KLJW
Architecture
& Design

Colossus,
Pilots Retreat,
St Mary's
Isles of Scilly
TR21 0PB

REF: P/22/059/FUL

LOCATION PLAN
1:2500

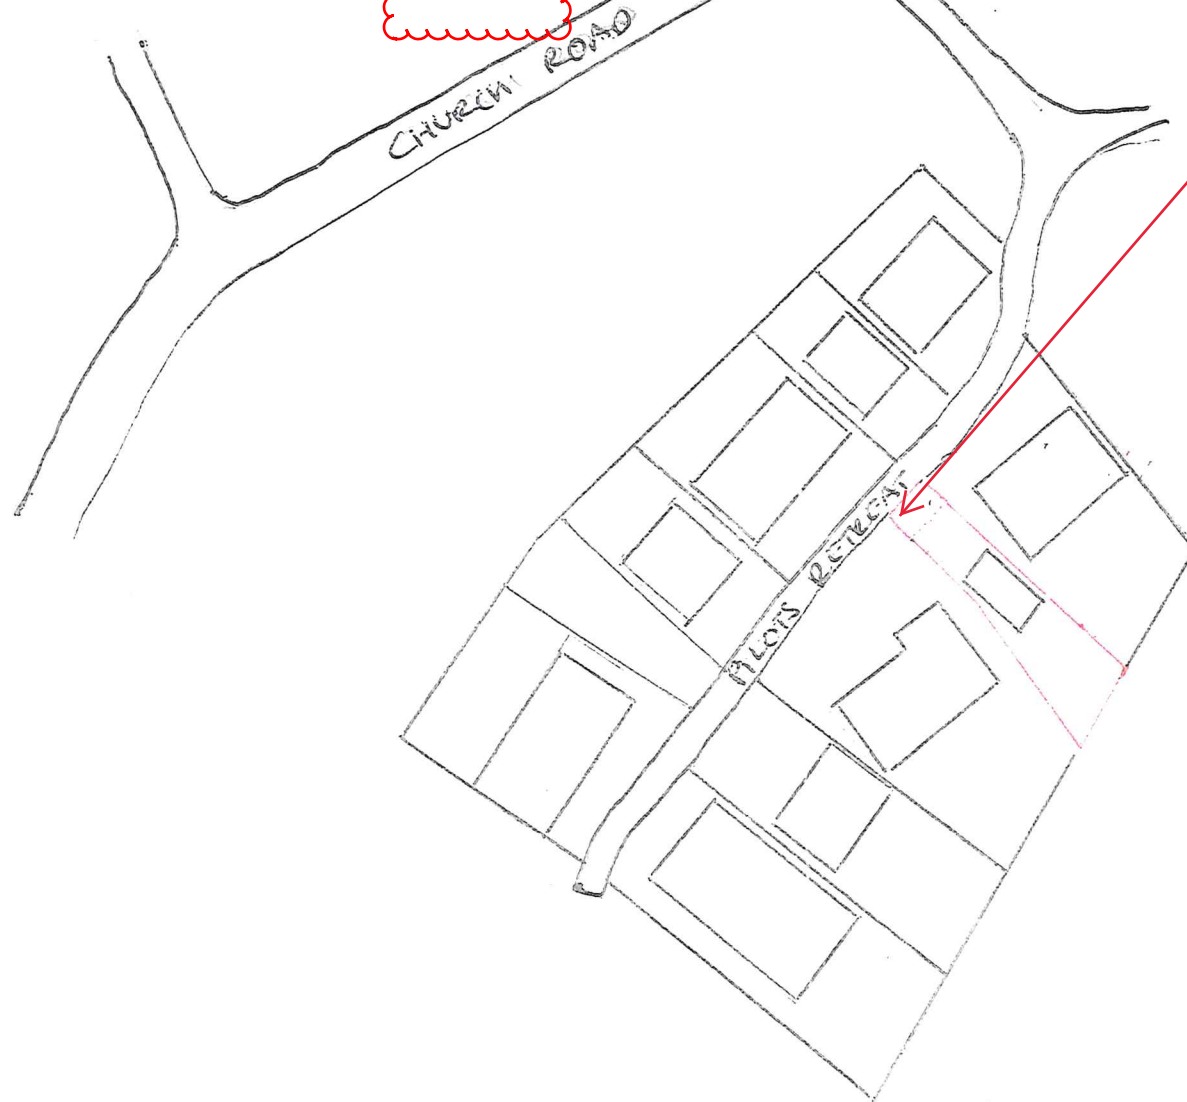
Incorrect north arrow. Location plan contradicts this North arrow, so application should not have been made valid.

Site boundary is incorrect relative to titles #CL112572 and #CL366405 held at the land registry

Drawing has no scale bar, although not a legislative requirement. The plot is not clearly outlined in red to determine the site in question and only two roads are named. The size of paper is not noted either so printing on different sizes will change the scale.

Information such as land required for access to the site from a public highway, visibility splays, landscaping, car parking and open areas around the building have not been identified, as required by the NPPF.

No key to identify site boundary.

Plot numbers have not been shown and neither have property names, so the site plan does not locate or orient the application site accurately.

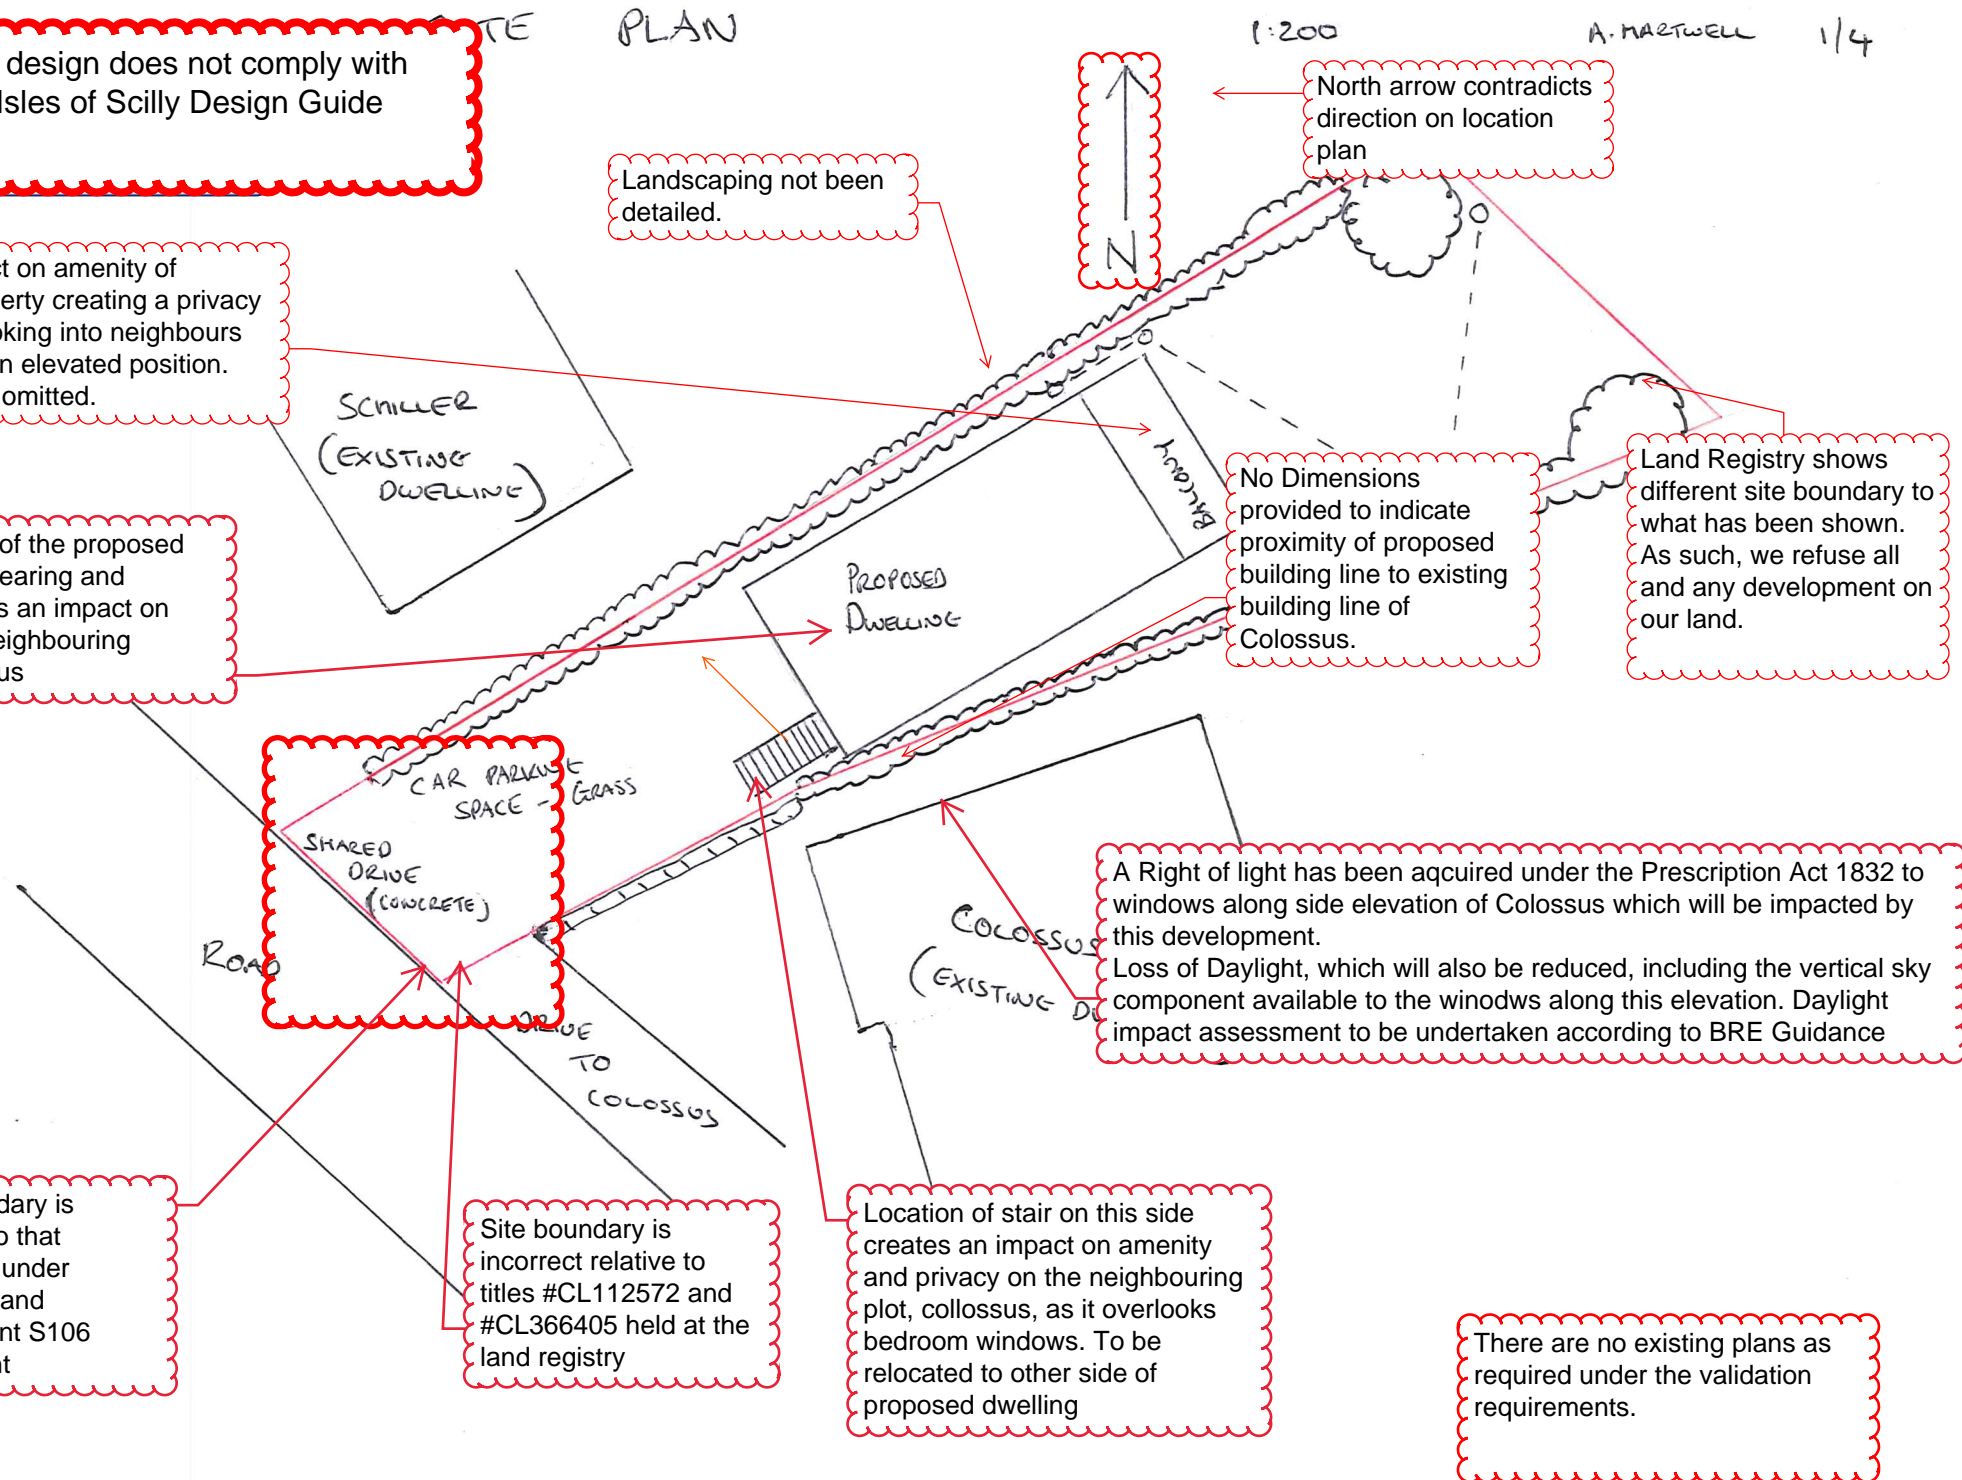
The design does not comply with the Isles of Scilly Design Guide

Serious impact on amenity of adjoining property creating a privacy issue. Overlooking into neighbours garden from an elevated position. Balcony to be omitted.

Scale and mass of the proposed dwelling is overbearing and subsequently has an impact on amenity of the neighbouring property, Colossus

Site boundary is contrary to that approved under P-17-083 and subsequent S106 agreement

Site boundary is incorrect relative to titles #CL112572 and #CL366405 held at the land registry

Location of stair on this side creates an impact on amenity and privacy on the neighbouring plot, collossus, as it overlooks bedroom windows. To be relocated to other side of proposed dwelling

Landscaping not been detailed.

North arrow contradicts direction on location plan

No Dimensions provided to indicate proximity of proposed building line to existing building line of Colossus.

Land Registry shows different site boundary to what has been shown. As such, we refuse all and any development on our land.

A Right of light has been acquired under the Prescription Act 1832 to windows along side elevation of Colossus which will be impacted by this development. Loss of Daylight, which will also be reduced, including the vertical sky component available to the windows along this elevation. Daylight impact assessment to be undertaken according to BRE Guidance

There are no existing plans as required under the validation requirements.

ELEVATIONS 1/3

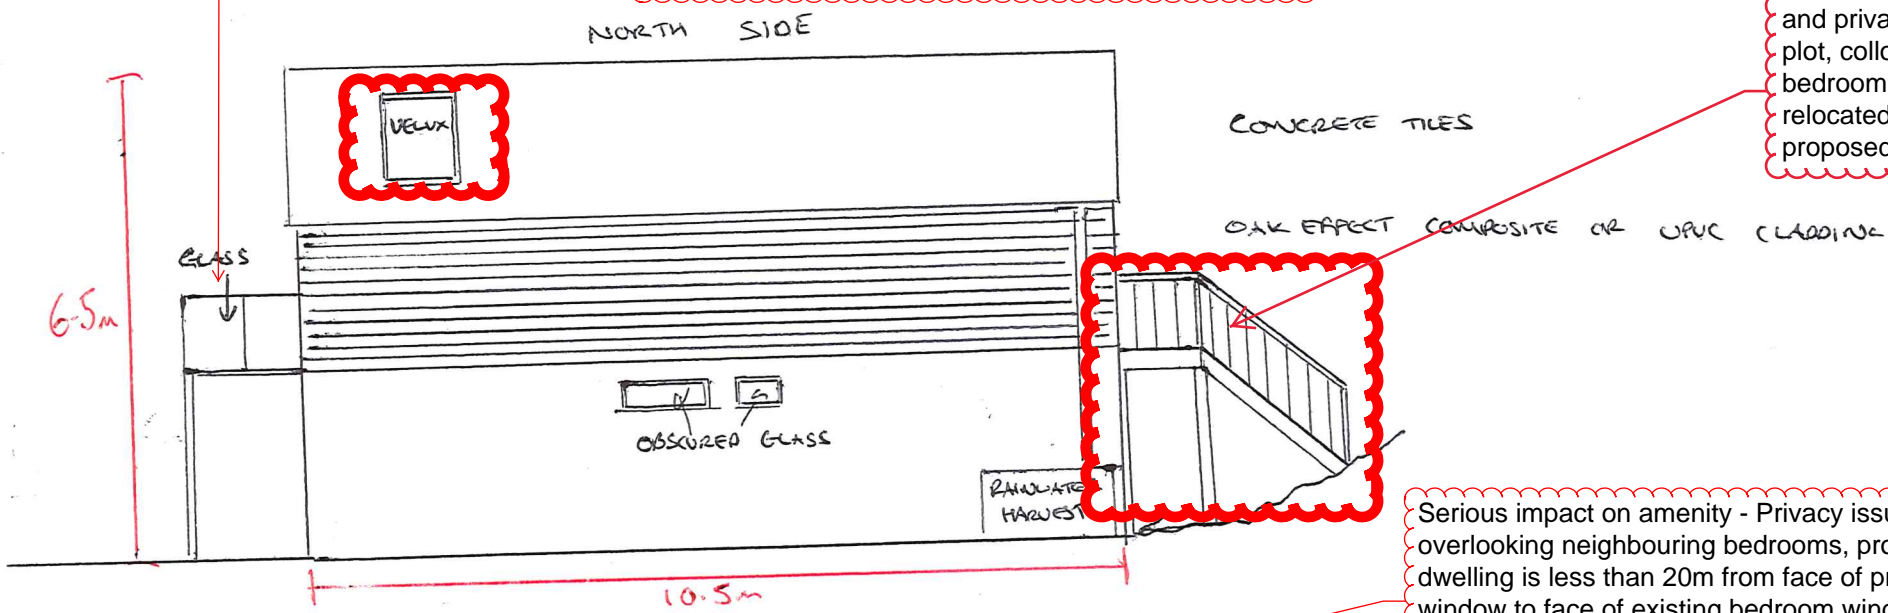
Ambiguity of materials being specified

Quality of proposed material is not in keeping with the character of the area

Second story being added, contrary to the P-17-803 approved scheme. This is over development of the site and out of scale with the street scene thus having a negative impact

A Right of light has been acquired under the Prescription Act 1832 to windows along side elevation of Colossus which will be impacted by this development.
Loss of Daylight, which will also be reduced, including the vertical sky component available to the windows along this elevation. Daylight impact assessment to be undertaken according to BRE Guidance

What is this?

Elevation doesn't show balcony. Which is correct.

Serious impact on amenity of adjoining property creating a privacy issue. Overlooking into neighbours garden from an elevated position. Balcony to be omitted.

Location of stair on this side creates an impact on amenity and privacy on the neighbouring plot, Colossus, as it overlooks bedroom windows. To be relocated to other side of proposed dwelling

Proximity of the adjoining neighbouring property has not been communicated to allow officers to make an informed decision

Serious impact on amenity of adjoining property creating a privacy issue. Overlooking into neighbours garden from an elevated position. Balcony to be omitted.

Scale and mass of the proposed dwelling is overbearing and subsequently has an impact on amenity of the neighbouring property, Colossus

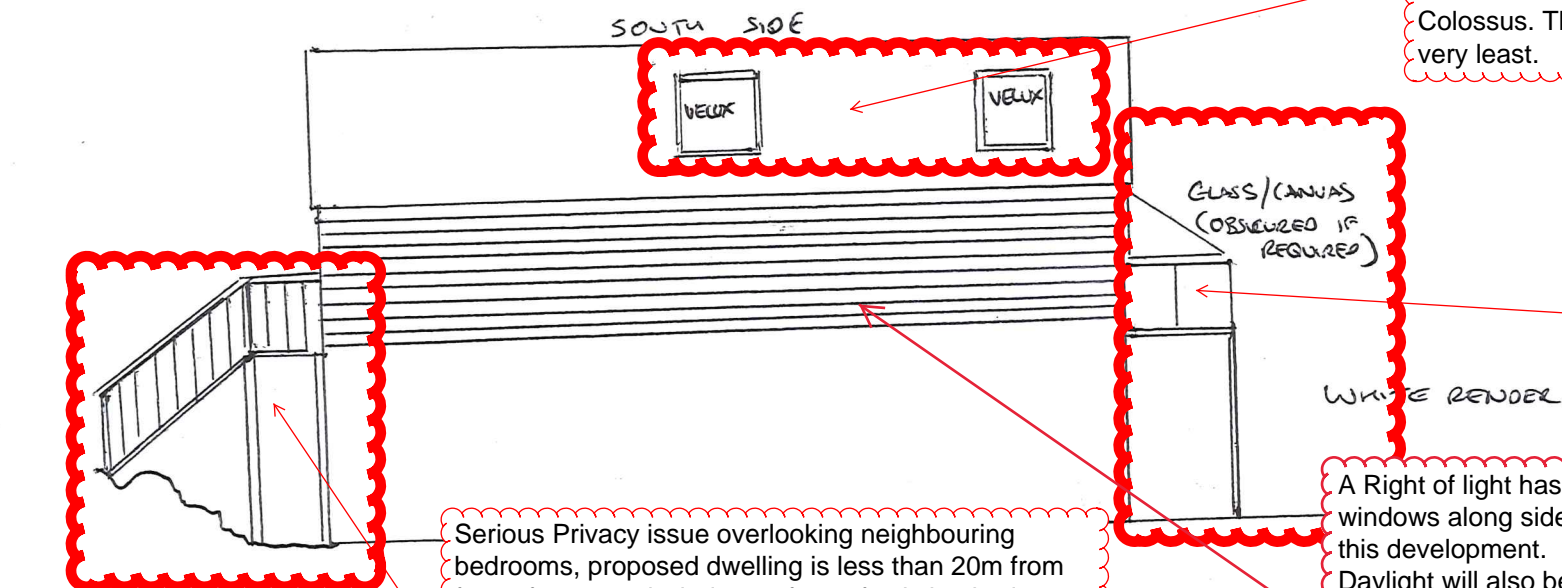
Serious impact on amenity of adjoining property creating a privacy issue. Overlooking into neighbours garden from an elevated position. Balcony to be omitted.

Location of stair on this side creates an impact on amenity and privacy on the neighbouring plot, collossus, as it overlooks bedroom windows. To be relocated to other side of proposed dwelling

Serious impact on amenity - Privacy issue with overlooking neighbouring bedrooms, proposed dwelling is less than 20m from face of proposed window to face of existing bedroom windows on Colossus. These windows should be obscure at the very least.

Serious impact on amenity of adjoining property creating a privacy issue. Overlooking into neighbours garden from an elevated position. Balcony to be omitted.

Serious Privacy issue overlooking neighbouring bedrooms, proposed dwelling is less than 20m from face of proposed window to face of existing bedroom windows on Colossus.

A Right of light has been acquired under the Prescription Act 1832 to windows along side elevation of Colossus which will be impacted by this development. Daylight will also be reduced, including the vertical sky component available to the windows along this elevation. Daylight impact assessment to be undertaken according to BRE Guidance

No sections have been provided as required under the validation requirements for sloping sites

ELEVATIONS

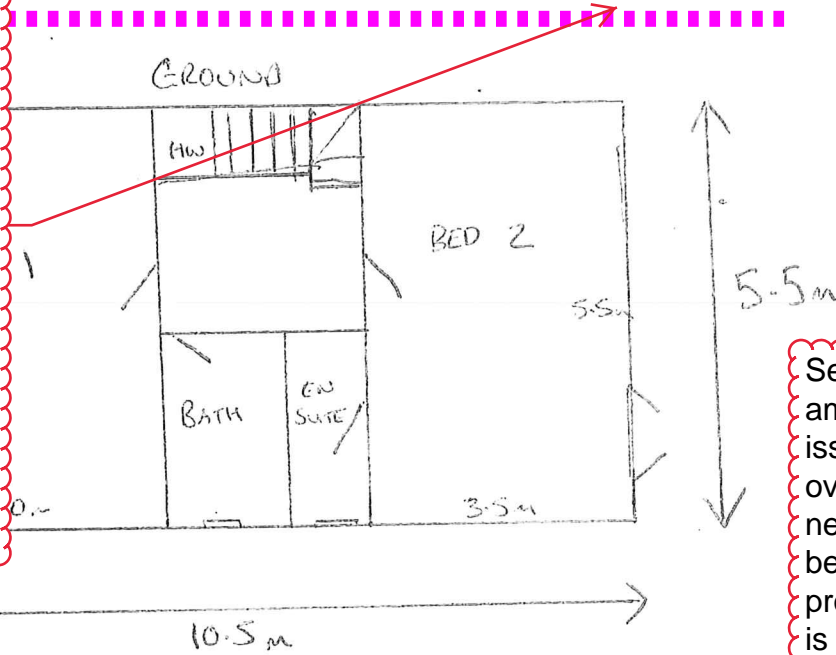
Ridge height to be communicated from streetscene at front, not rear. To be as per previous permission granted which lines up with Colossus.

Overshadowing, loss of sunlight and daylight to existing premises, is analysed using annual probable sunlight hours (APSH). This analysis is absent in the application

Second story being added, contrary to the P-17-803 approved scheme. This is over development of the site and out of scale with the street scene thus having a negative impact

This plot is part of the subdivided Colossus plot and should therefore reference that with datums such as ridge height, not the further away ridge height of Schiller, which furthermore, sits on an elevated position relative to Colossus.

Design of property is not in accordance with section 3 of the Isles of Scilly design guide, building on sloping sites.

Scale and mass of the proposed dwelling is overbearing and subsequently has an impact on amenity of the neighbouring property, Colossus

Overshadowing: Sunshine in gardens and open spaces. BRE Guidelines recommend that at least half of the garden or open space can receive at least two hours sunlight on March 21 with the proposed dwelling in situ. Analysis absent from application.

Proximity of the adjoining neighbouring property has not been accurately communicated to allow officers to make an informed decision. The rear elevation has been shown to skew the view and lessen the perceived impact. A front elevation in context should be produced. Bottom line is that there's not enough or good enough quality of information in the submission to allow officers to make an informed decision on the scheme.

Negative impact on amenity

Proposal assumes the ability to extensively excavate a steep sloping site, in doing so, undermining the foundations of the neighbouring building and it's utility services, including foul water service pipes.

FLOORPLAN

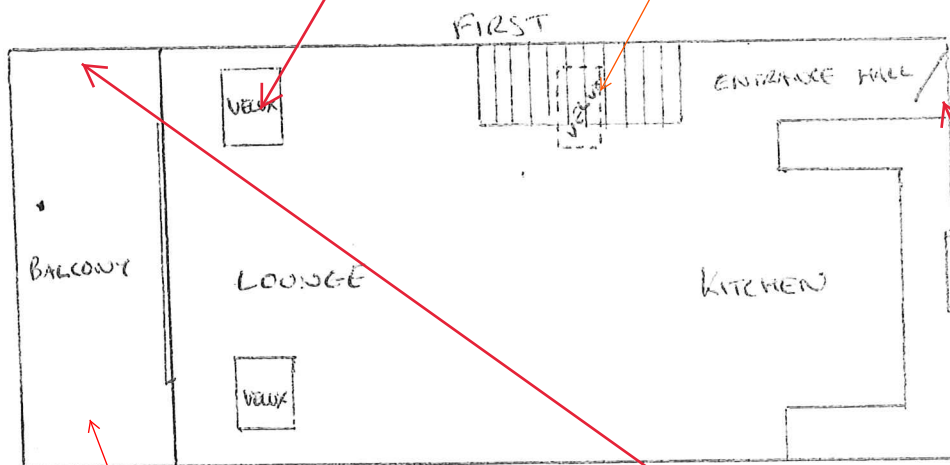
Proximity of the adjoining neighbouring property has not been accurately communicated to allow officers to make an informed decision. The rear elevation has been shown to skew the view and lessen the perceived impact. A front elevation in context should be produced.

Bottom line is that there's not enough or good enough quality of information in the submission to allow officers to make an informed decision on the scheme.

Serious impact on amenity - Privacy issue with overlooking neighbouring bedrooms, proposed dwelling is less than 20m from face of proposed window to face of existing bedroom windows on Colossus. These windows should be obscure at the very least.

stairs to gain access not shown

Serious Privacy issue overlooking neighbouring bedrooms, proposed dwelling is less than 20m from face of proposed window to face of existing bedroom windows on Colossus.

No privacy screens shown as per elevations / other drawings.

No Roof Plan.

No North Arrow to orient the building on the site.

Generally, the design does not comply with the Isles of Scilly Design guide, section 3 'Adjacent Properties'
